SUBJECT: Coastside Design Review Recommendation
Cortez Avenue, Miramar
APN 048-032-070; County File No. PLN 2018-00397

At its meeting of April 11, 2019, the San Mateo County Coastside Design Review Committee (CDRC) considered your application for design review recommendation to allow construction of a new 1,732 sq. ft., two-story single-family residence, plus a 380 sq. ft. two-car attached garage, located on an existing 4,400 sq. ft. legal non-conforming parcel (legality confirmed via PLN2014-00116), as part of a hearing-level Coastal Development Permit (CDP) and a Non-Conforming Use Permit (UP). The Use Permit is required to allow development on a non-conforming parcel that proposes right and left side setbacks of 5 feet. and 7 feet., respectively, where 10 feet. is the minimum allowed for each side. No trees are proposed for removal. The Coastside Design Review Committee was unable to determine the findings for design review approval based on certain design deficiencies. In order to resolve these deficiencies in the project's design, a more thorough review of the "Standards for Design for One-Family and Two-Family Residential Development in the Midcoast" manual is required, with

Exterior LIGHTENING Plan

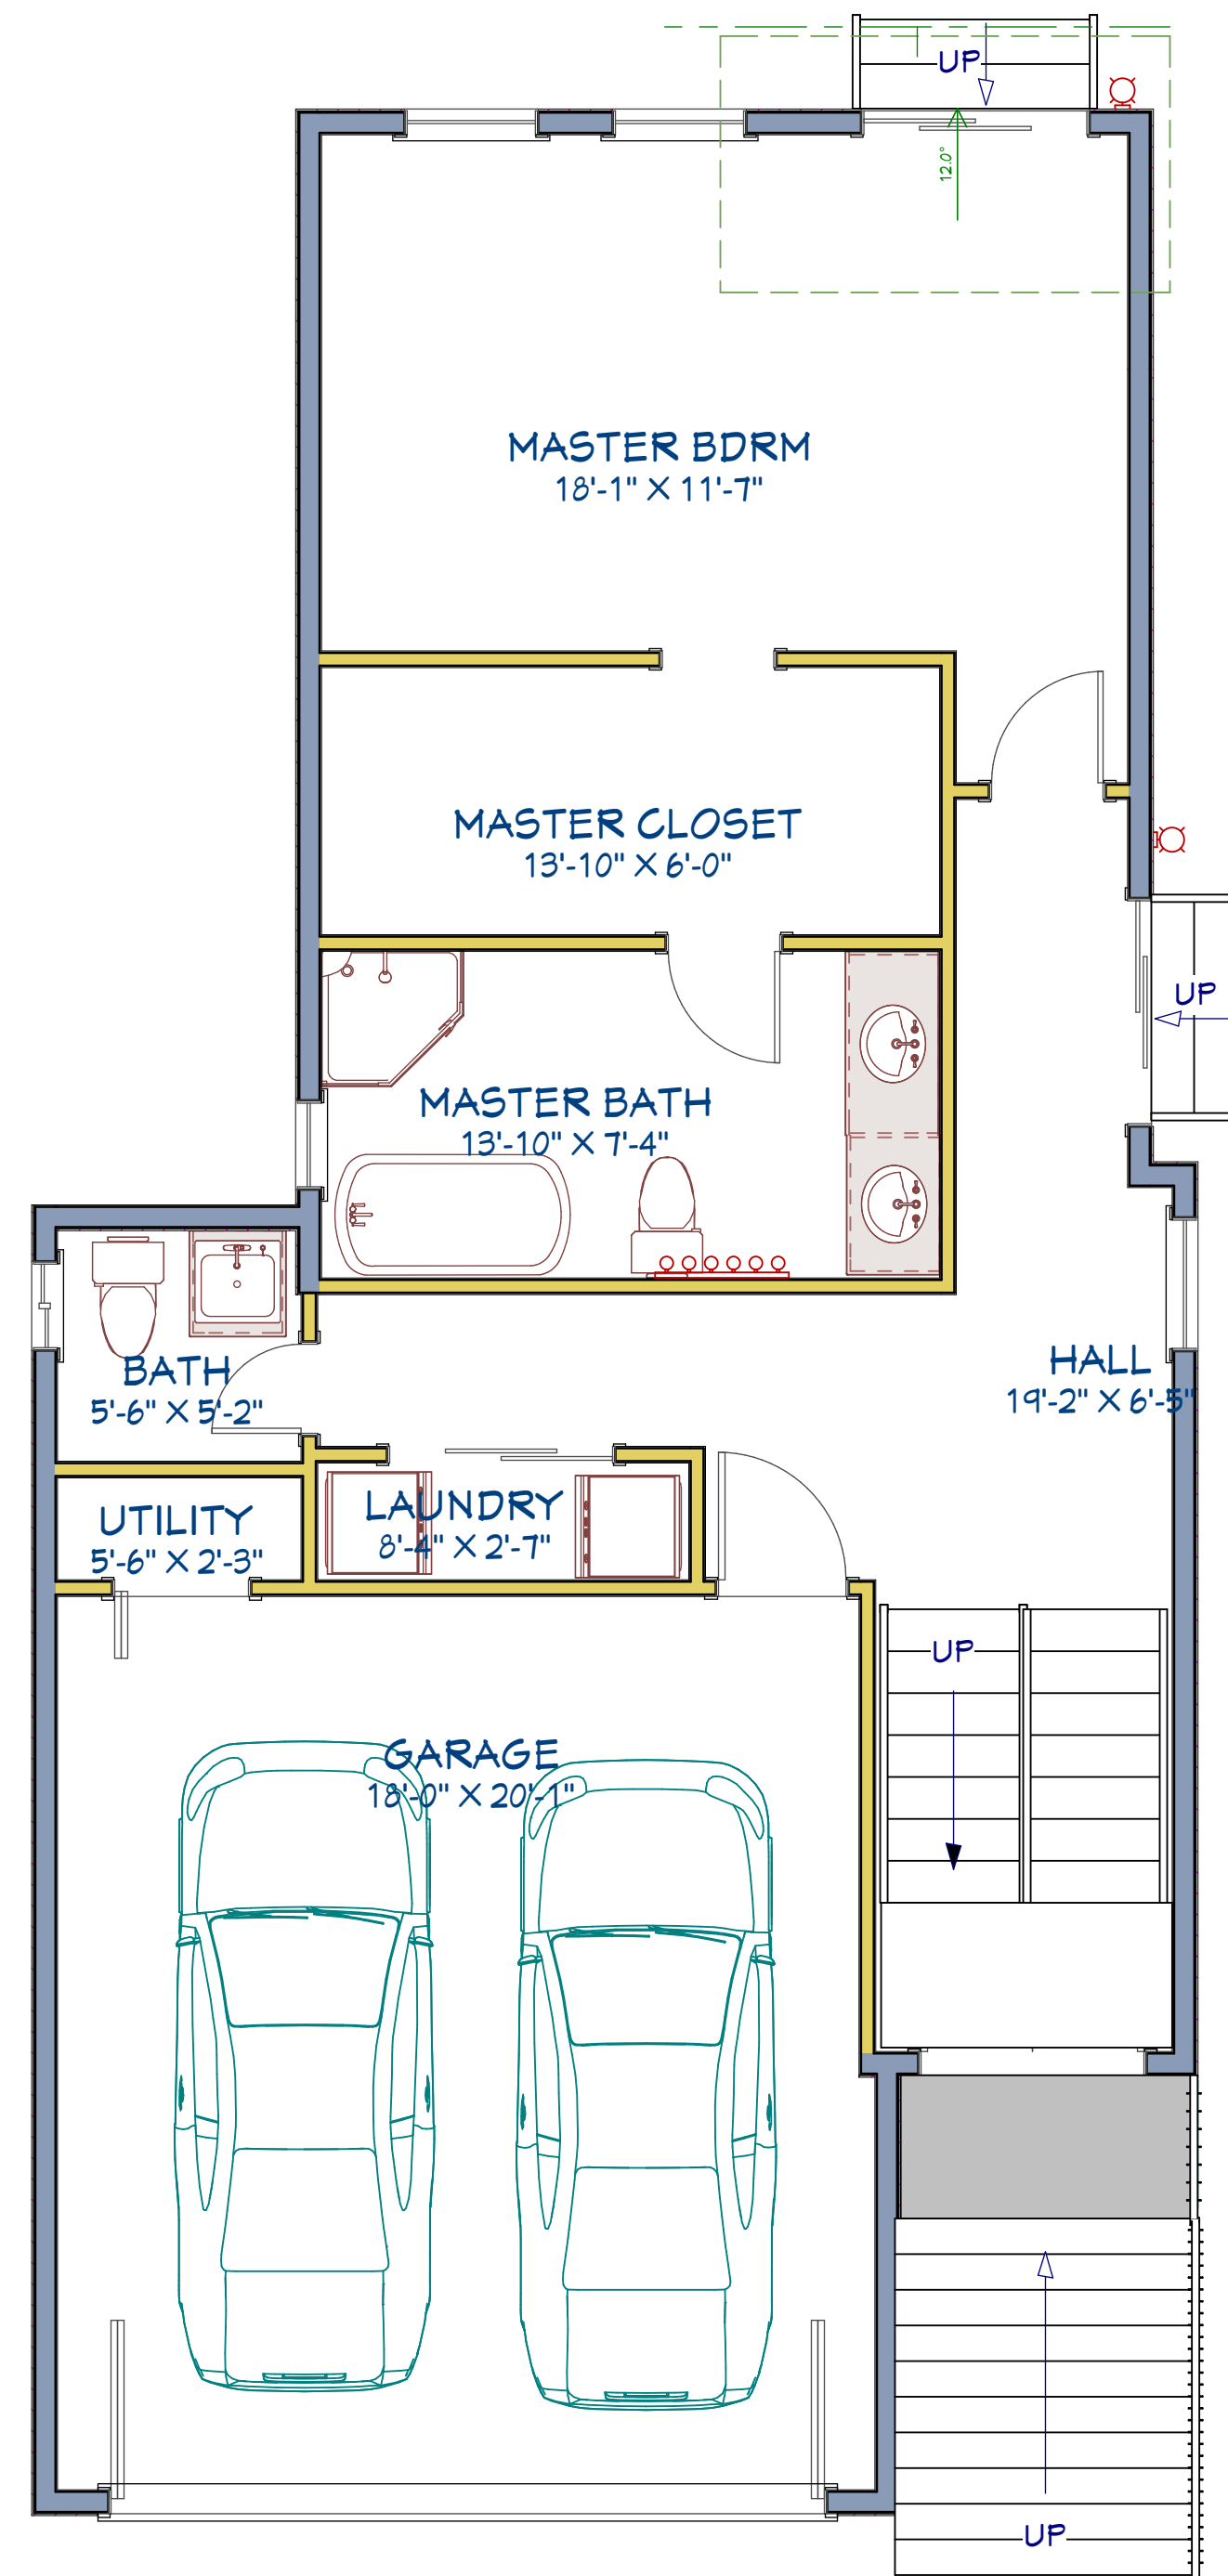
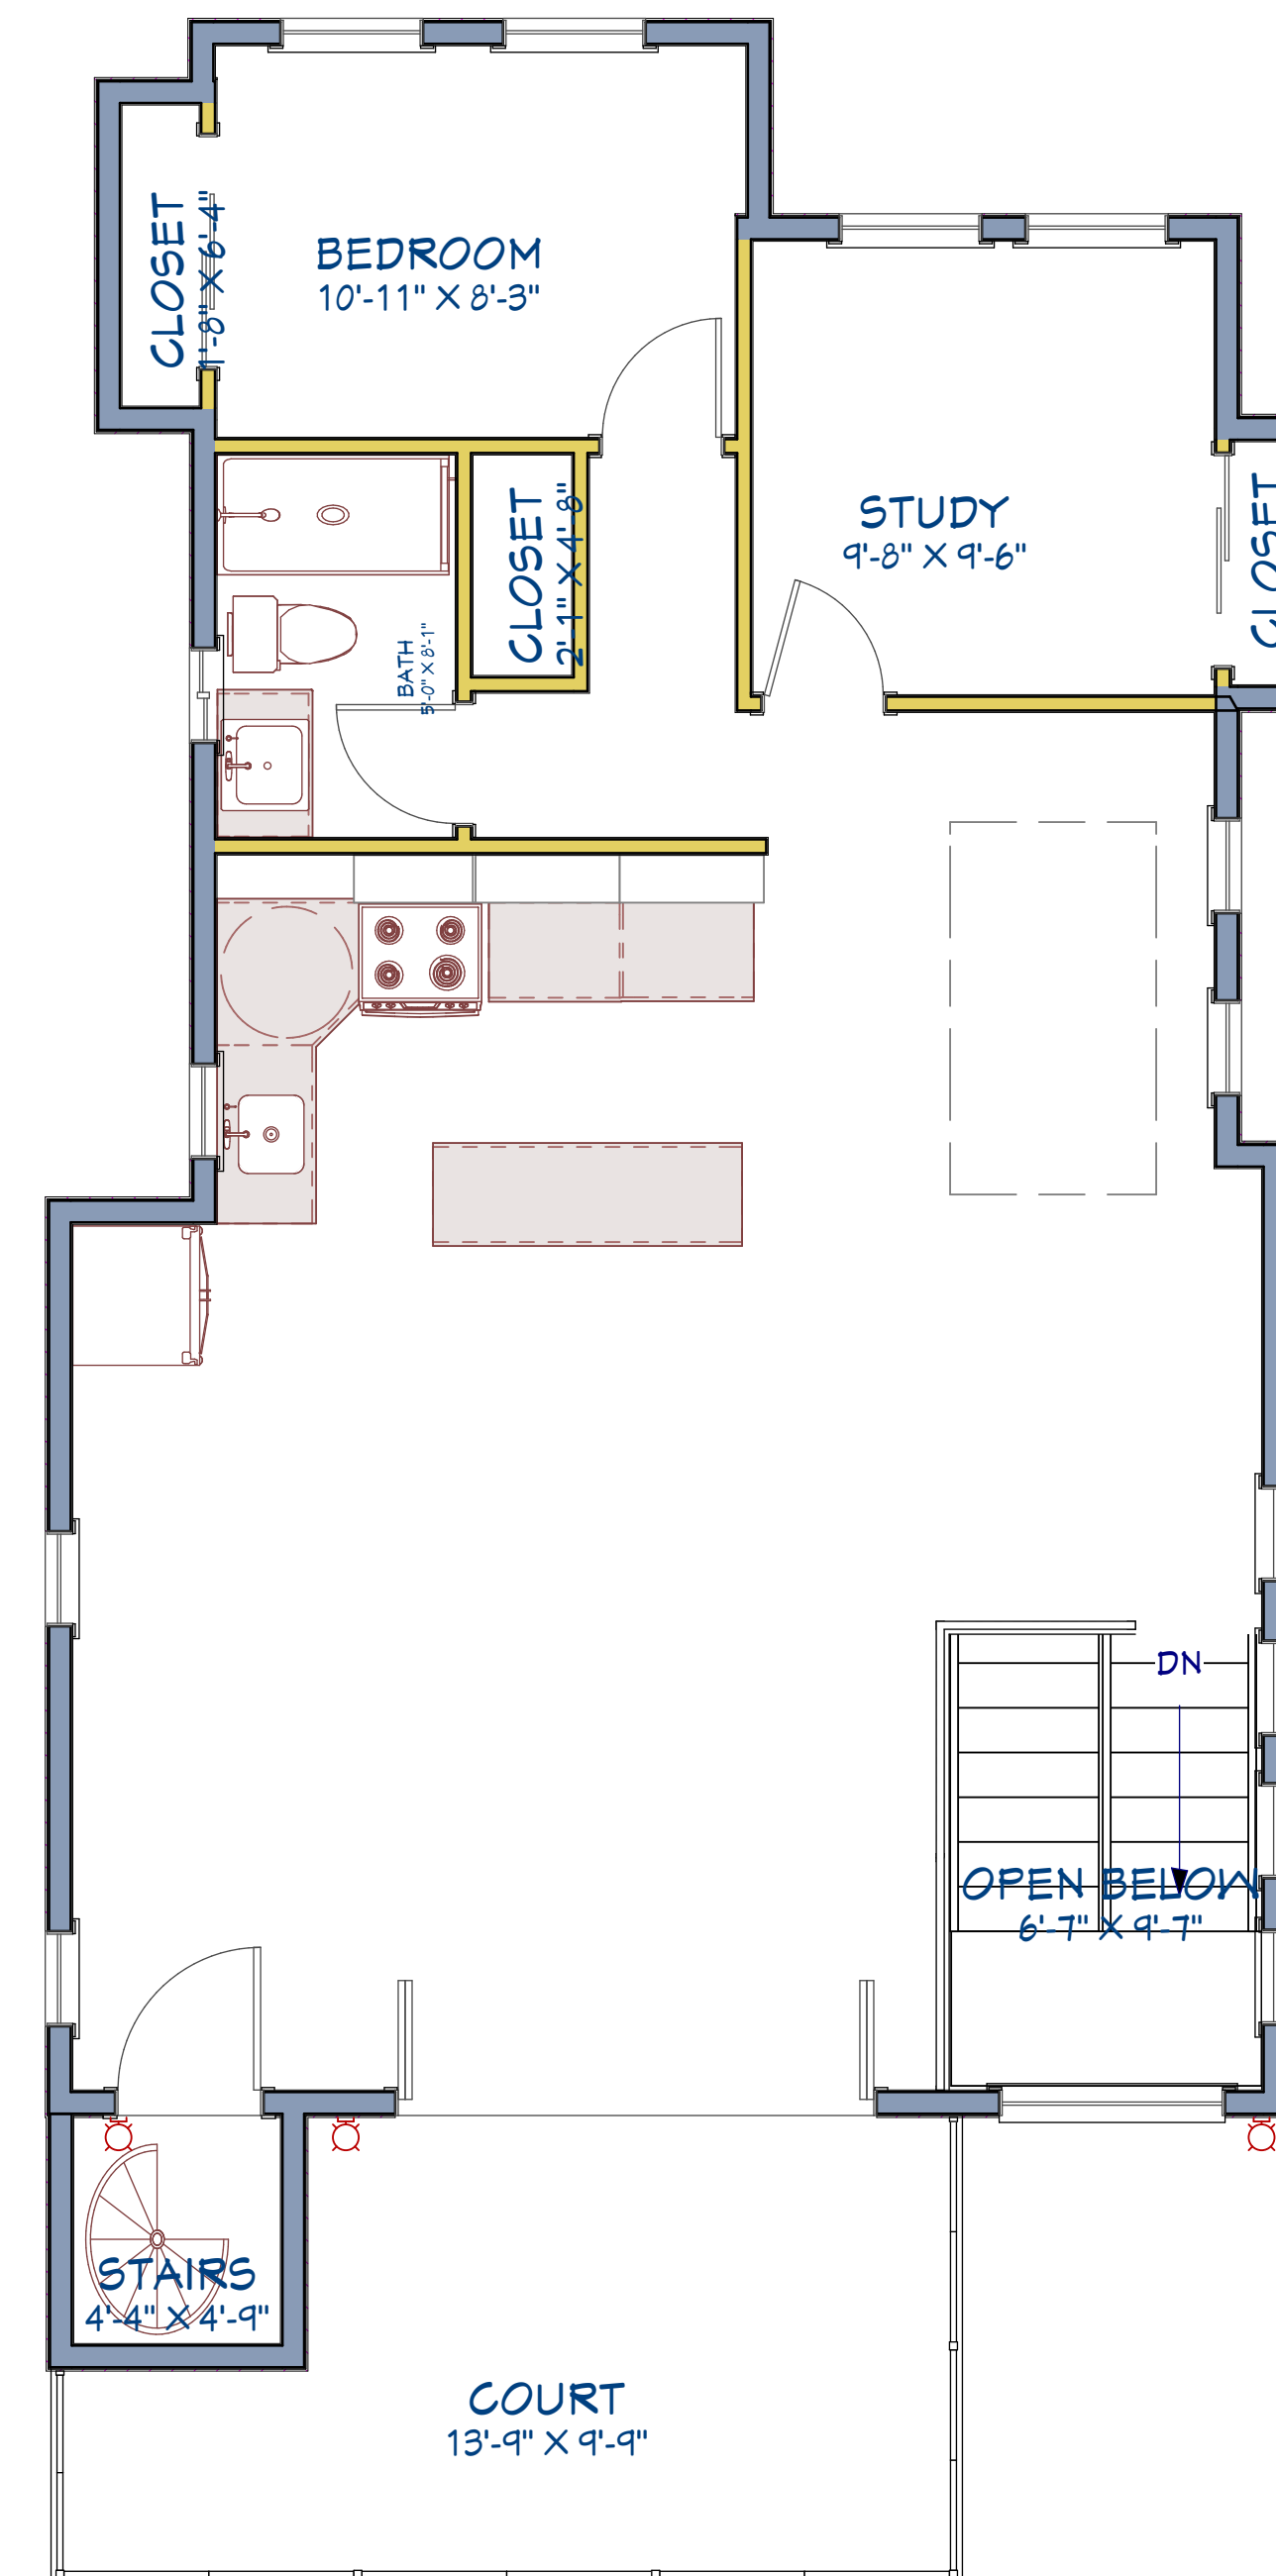
1. Outdoor lighting reduced to one light fixture near doors only.
2. Reduce number of windows and amount of glass due to reflectivity and privacy concerns for neighbors.
3. Coordinate window head/sill heights to be consistent.

- Outdoor lighting reduced to one light fixture near doors only.
Redesign: Remove all lighting. Total exterior light now reduced to 5. 2 for front patio and then 1 each exterior door.

Reduced Ligtening only 4 exteiror lights total
